TOP DRIVE
PRODUCT BULLETINS

CANRIG TD PRODUCT BULLETIN MANUAL

CANRIG DRILLING TECHNOLOGY LTD

Fig. 4

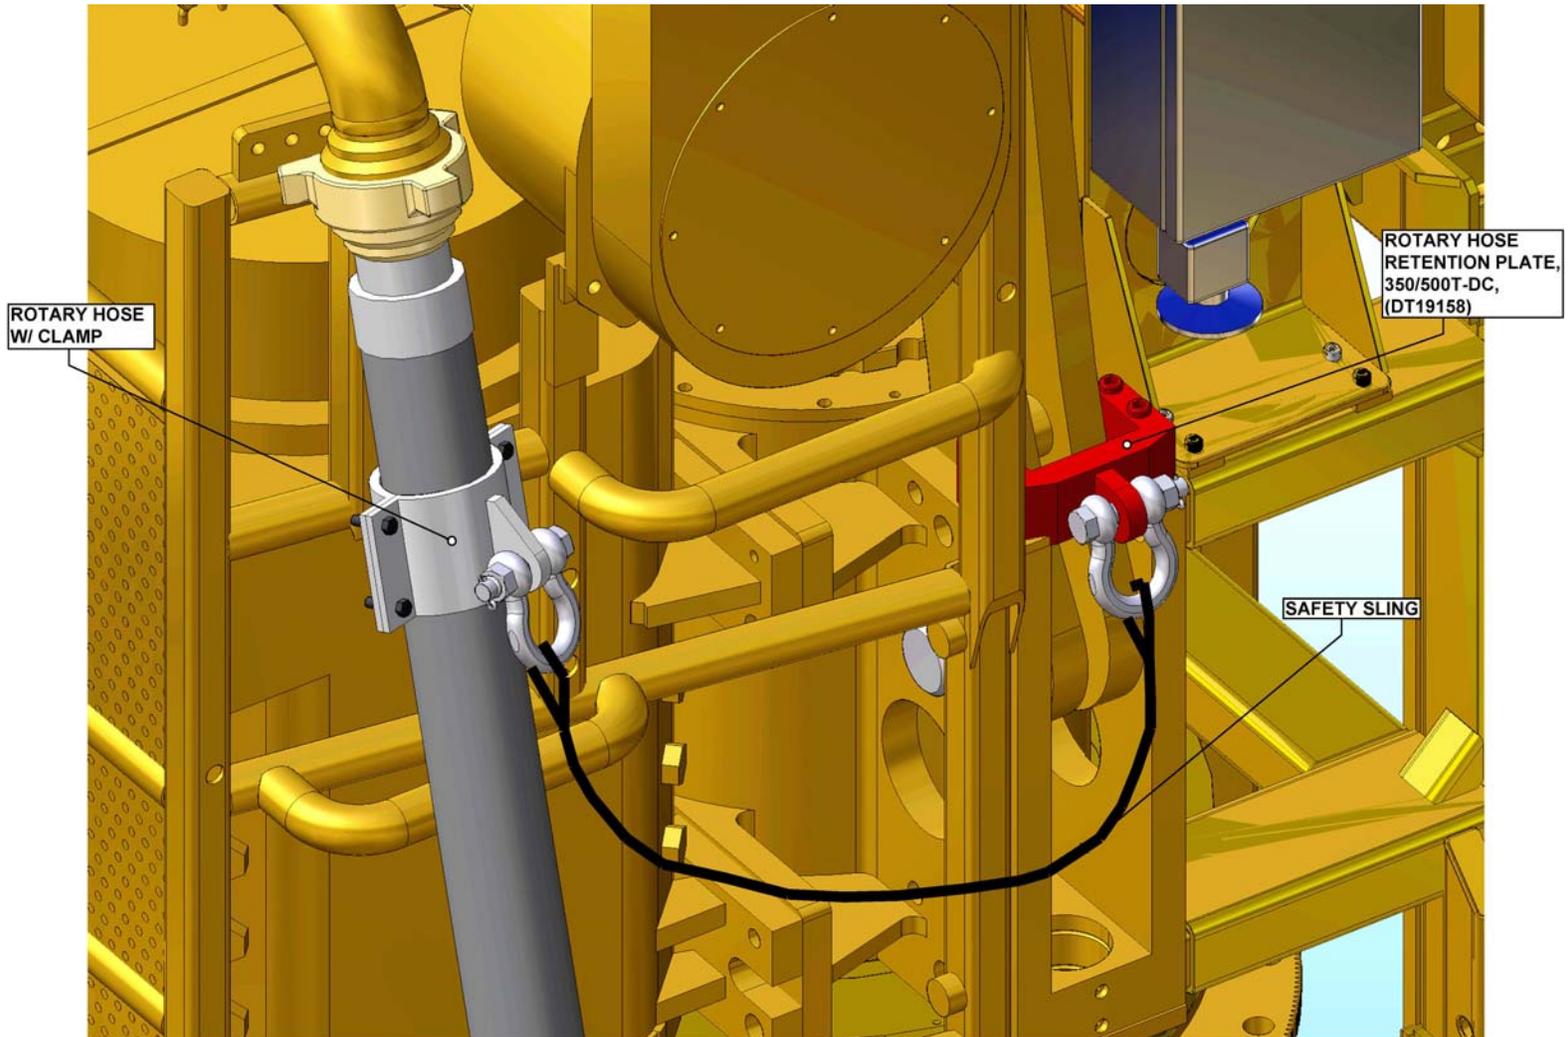
1. Remove existing Upper Link Retainer with (2) $\frac{3}{4}$ "-10UNC 1 $\frac{1}{2}$ " LG capscrews and replace with Rotary Hose Retention Kit (AY16686) for 350/500T-DC which includes Rotary Hose Retention Plate (DT19158) with (4) $\frac{3}{4}$ "-10UNC x 4" (SH-0750NC-0400-W) capscrews and (4) Nordloc washers (LW-0750-NLS). See Fig. 4.
2. Torque the (4) $\frac{3}{4}$ "-10UNC x 4" (SH-0750NC-0400-W) capscrews to 350 ft-lbs and safety wire with (M21-2000-010) and (M19-3006-010).
3. Install one end of sling to shackle and attach to lug in Rotary Hose Retention Plate (DT19158). (Sling and shackle supplied by customer.)
4. Install other end of sling to other shackle and install on the Rotary Hose Clamp. Tie-wrap sling to eliminate excess slack with (E03-2000-010). Final assembly should be as shown in Fig. 4.

Fig. 1

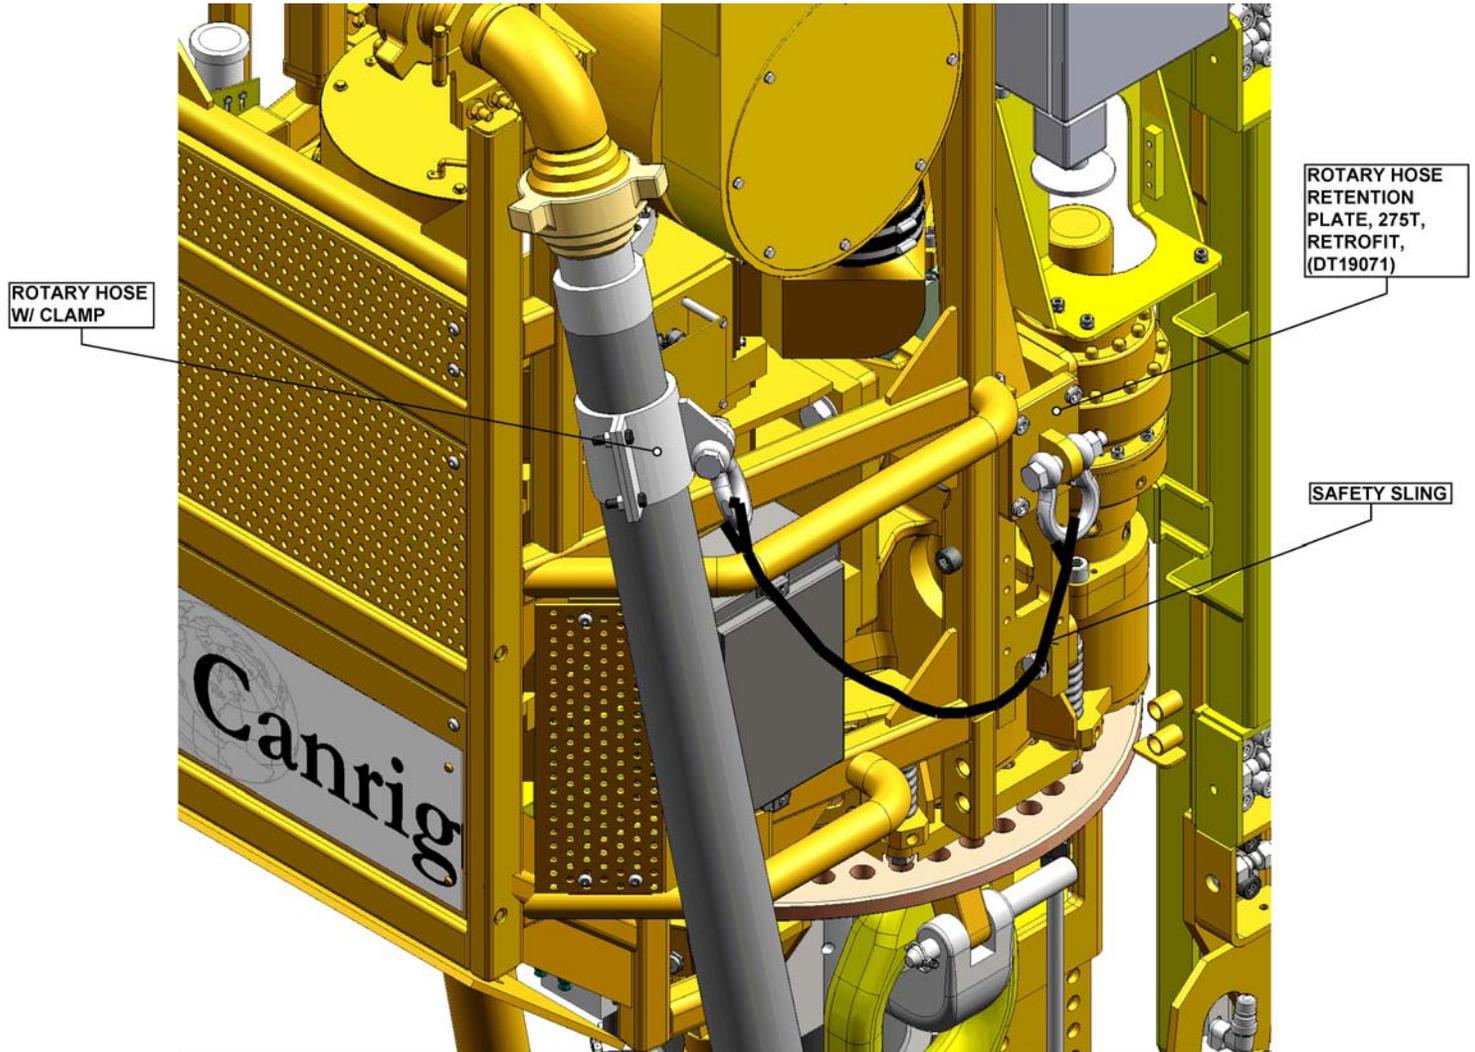
1. Refer to included drawing (DT19072) for Top Drive Housing modification to drill and tap (4) holes at specified dimensional location in drawing. See Fig. 1.
2. After holes are tapped, install Rotary Hose Retention Plate (DT19071) with (4) 3/4"-10UNC x 1 1/4" (SH-0750NC-0125-W) capscrews and (4) Nordloc washers (LW-0750-NLS).
3. Torque the (4) 3/4"-10UNC x 1 1/4" (SH-0750NC-0125-W) capscrews to 350 ft-lbs and safety wire with (M21-2000-010) and (M19-3006-010).
4. Install one end of sling to shackle and attach to lug in Rotary Hose Retention Plate (DT19071). (Sling and shackle supplied by customer.)
5. Install the other of sling to shackle and attach on the Rotary Hose Clamp. Tie-wrap slings to eliminate excess slack with (E03-2000-010). Final assembly should be as shown in Fig 1.

Fig. 2

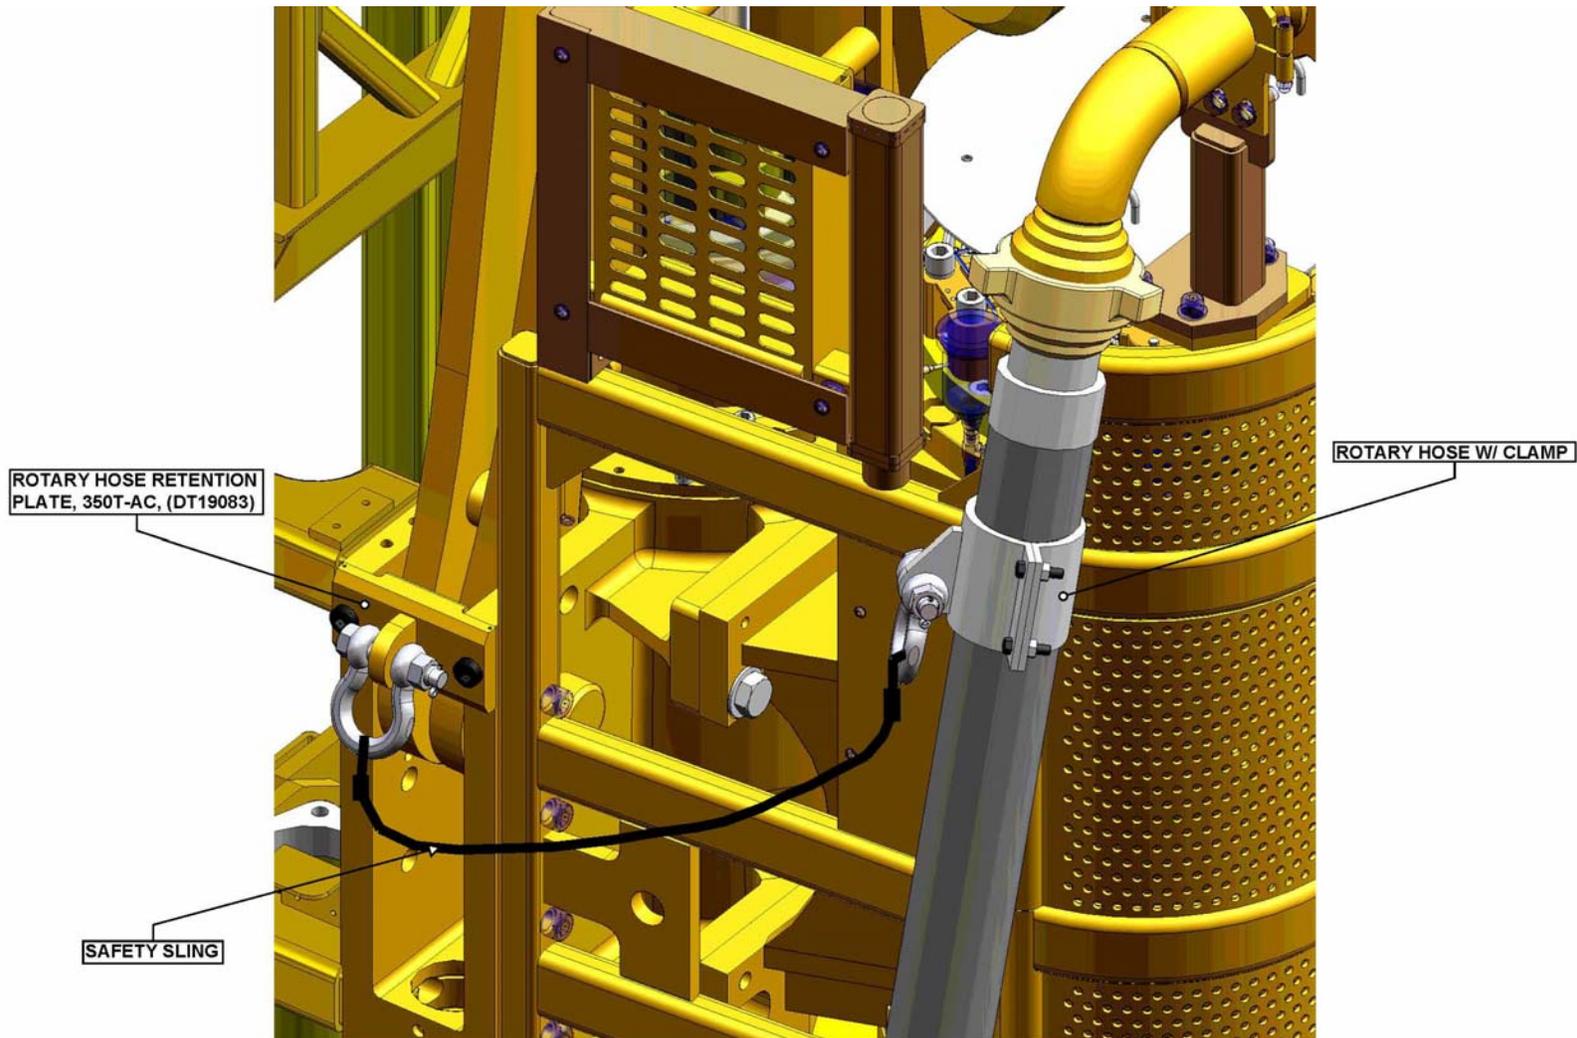
1. Refer to included drawing (DT19084) for Top Drive Housing Modification to drill and tap (2) holes at specified dimensional location in drawing. See Fig. 2.
2. After holes are tapped, install Rotary Hose Retention Plate (DT19083) with (2) 1"-8UNC x 2" (SH-1000NC-0200-W) capscrews and (2) Nordloc washers (LW-1000-NL).
3. Torque the (2) 1"-8UNC x 2" (SH-1000NC-0200-W) capscrews to 848 ft-lbs and safety wire with (M21-2000-010) and (M19-3006-010).
4. Install one end of sling to shackle and attach to lug in Rotary Hose Retention Plate (DT19083). (Sling and shackle supplied by customer.)
5. Install the other of sling to shackle and attach on the Rotary Hose Clamp. Tie-wrap sling to eliminate excess slack with (E03-2000-010) Final assembly should be as shown in Fig 2.

Fig. 3

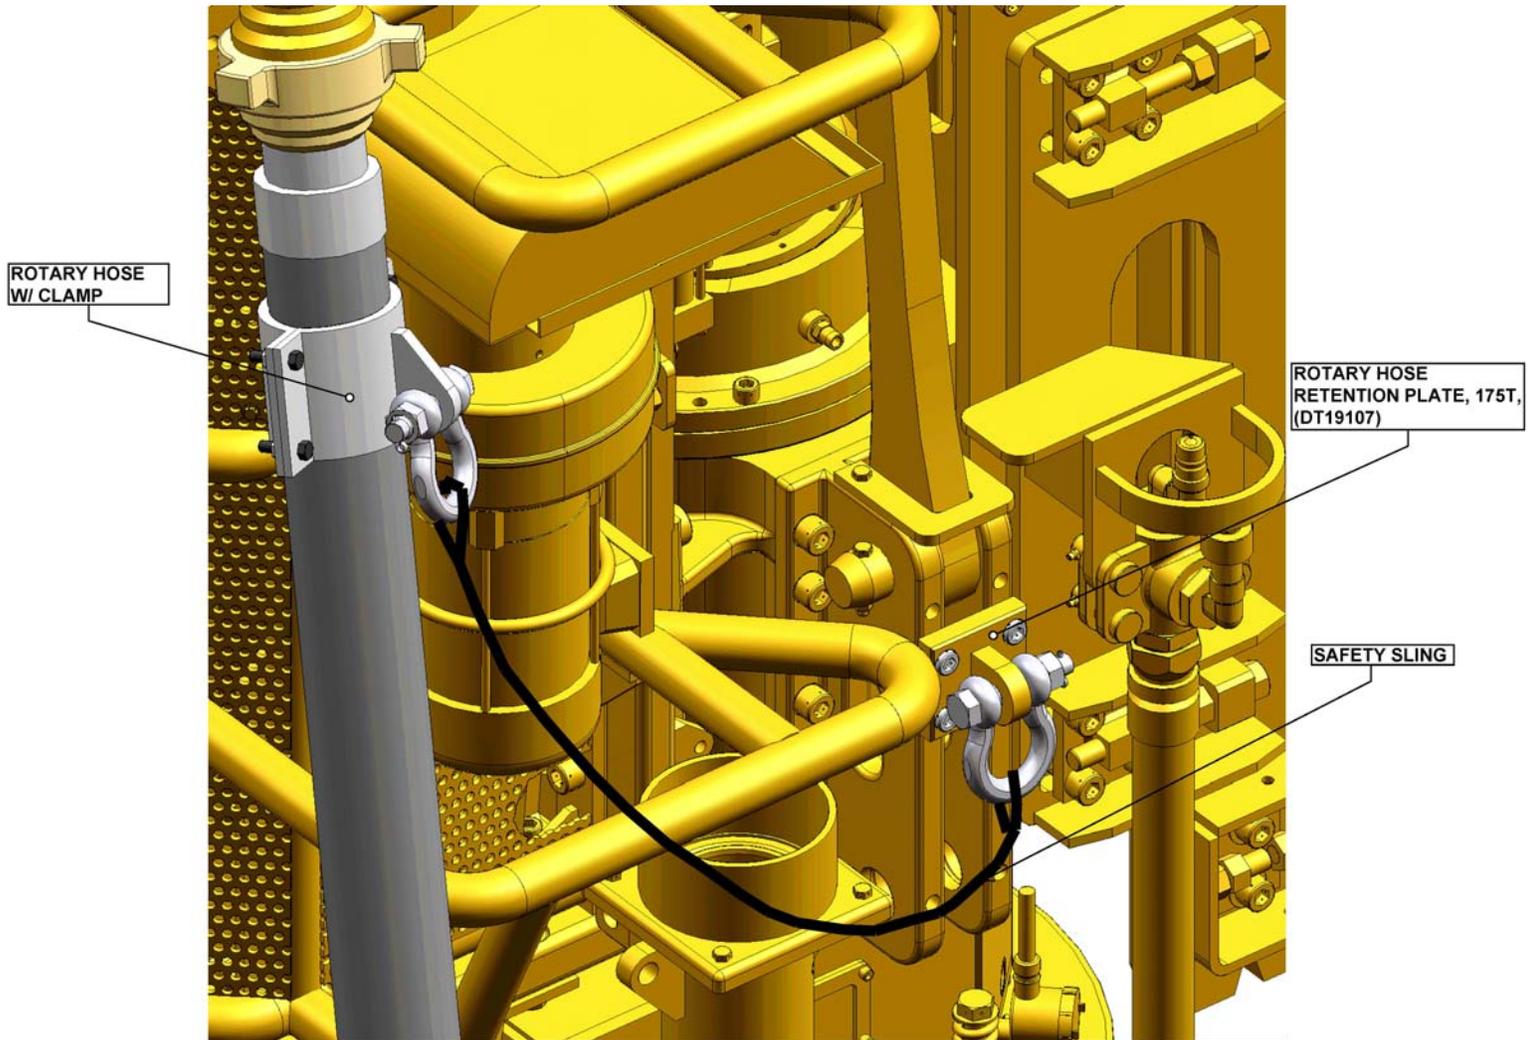
1. Refer to included drawing (DT19121) for Top Drive Housing modification to drill and tap (4) holes at specified dimensional location in drawing. See Fig. 3.
2. After holes are tapped, install Rotary Hose Retention Plate (DT19107) with (4) 3/4"-10UNC x 1 1/4" (SH-0750NC-0125-W) capscrews and (4) Nordloc washers (LW-0750-NLS)
3. Torque the (4) 3/4"-10UNC x 1 1/4" (SH-0750NC-0125-W) capscrews to 350 ft-lbs and safety wire with (M21-2000-010) and (M19-3006-010).
4. Install one end of sling to shackle and attach to lug in Rotary Hose Retention Plate (DT19107) . (Sling and shackle supplied by customer.)
5. Install the other of sling to shackle and attach on the Rotary Hose Clamp. Tie-wrap slings to eliminate excess slack with (E03-2000-010). Final assembly should be as shown in Fig 3.
